2016/2605/P & 2016/2635/A

5 Bernard Street WC1- 2016/2605/P

Delegated Report		Analysis sheet	Expiry Date:	05/07/2016
(Members Briefing)		N/A / attached	Consultation Expiry Date:	09/06/2016
Officer			Application Number(s)	
Matthias Gentet			1: 2016/2605/P 2: 2016/2635/A	
Application Address			Drawing Numbers	
5 Bernard Street LONDON WC1N 1LJ			See draft decision notices.	
PO 3/4	Area Team Signature	C&UD	Authorised Officer Signature	
Proposal(s)				
1: Replacement of existing shopfront and awning to restaurant (Class A3), and display of an externally illuminated fascia and projecting sign.				
2: Display of an externally illuminated fascia and projecting sign.				
Recommendation(s):		1: Grant Conditional Planning Permission 2: Grant Conditional Advert Consent		
Application Type:		Full Planning Permission Advert Consent

View of the current shopfront

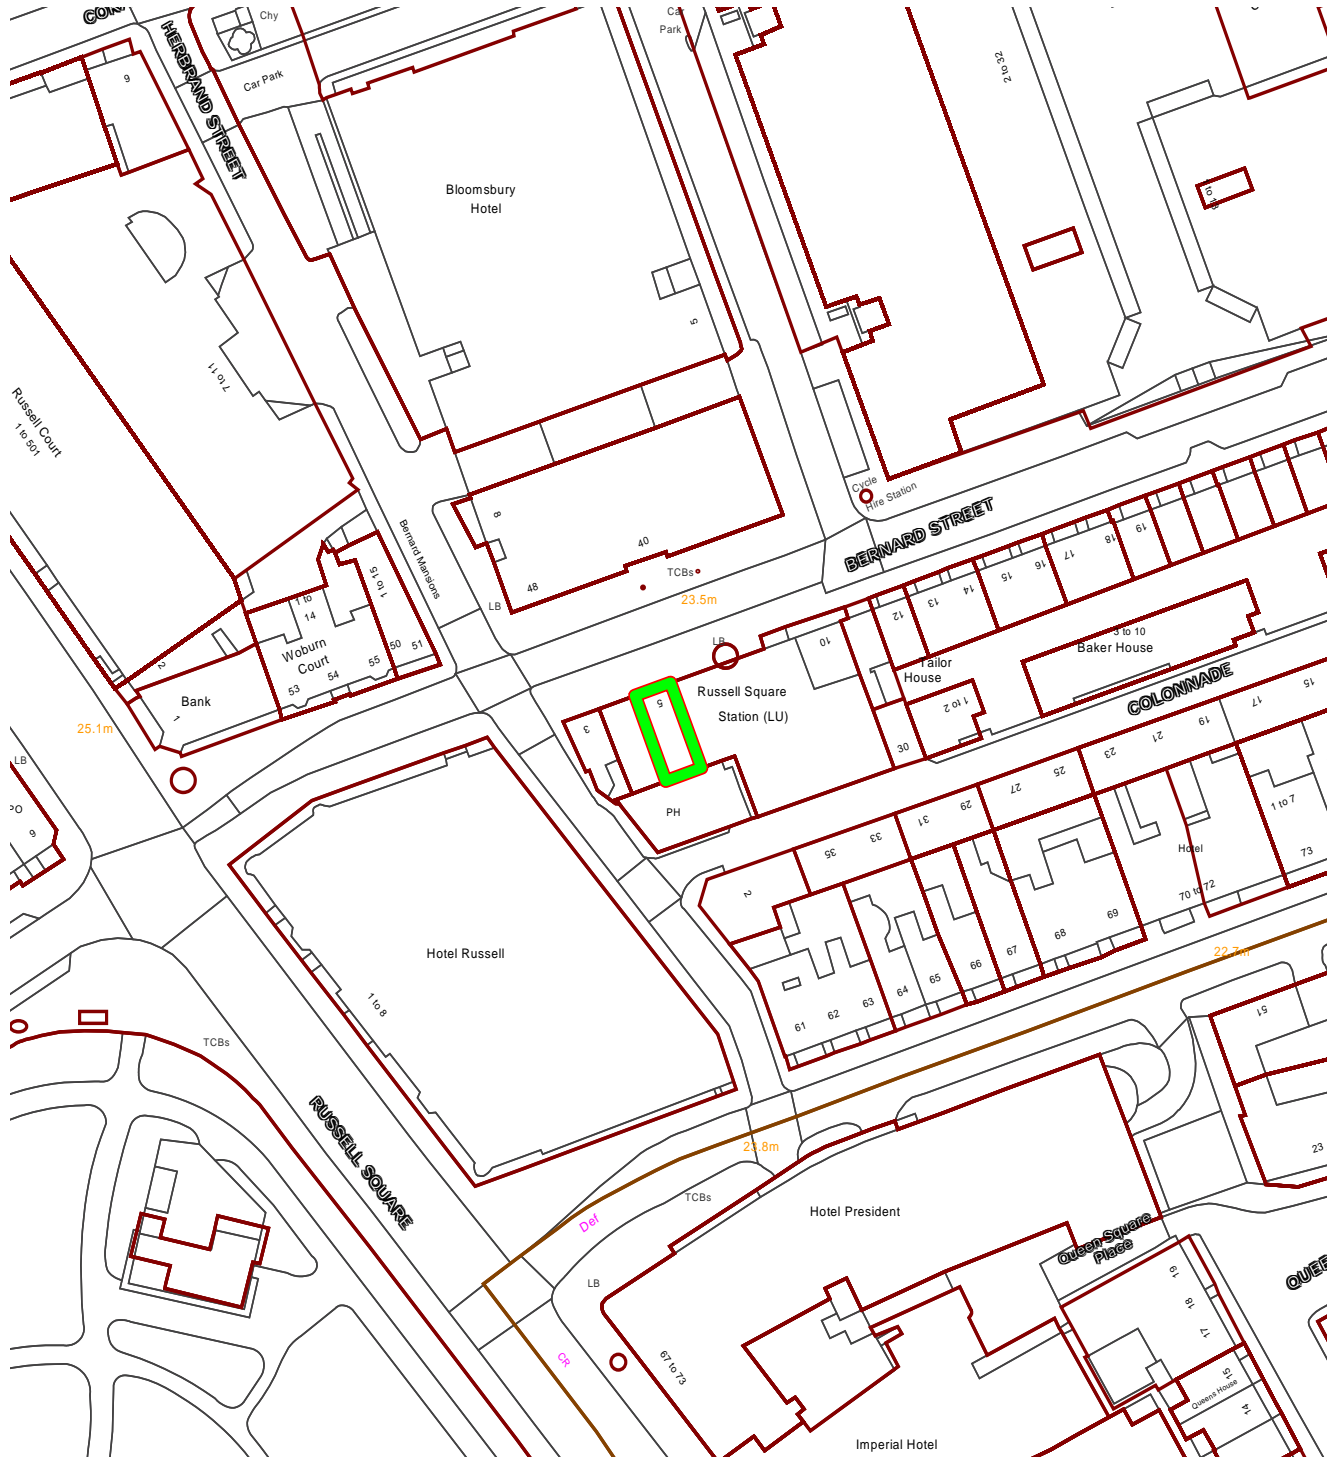
- Shop windows are confused between vertical and horizontal panes.
Officer's Response: see paragraph 2.3 (iii) & 3.2
- Building not listed at the time the rest of the terrace obtained its protection;
Officer's Response: Confirm that the building is not listed but is identified as making a positive contribution to the character and appearance of the conservation area

3.2 The proposed shopfront will improve the front elevation by replacing the dated existing shopfront, consisting of an ageing stained timber frame shopfront with small glazed panels and a brick slip clad stall riser, framed with rendered pilasters. The proposed shopfront, of a much more simple design, consists of a timber stall riser of a height of approximately just under 1m, a large glazed tier above measuring roughly 1.5m in height and with sliding windows, and a third smaller tier of a single glazing panel measuring around 0.7m in height. The removal of the transom bars has de-cluttered the design of the proposed shopfront, minimizing the impact of the vertical bars forming part of the sliding windows, and producing a more sympathetic and overall cleaner design.
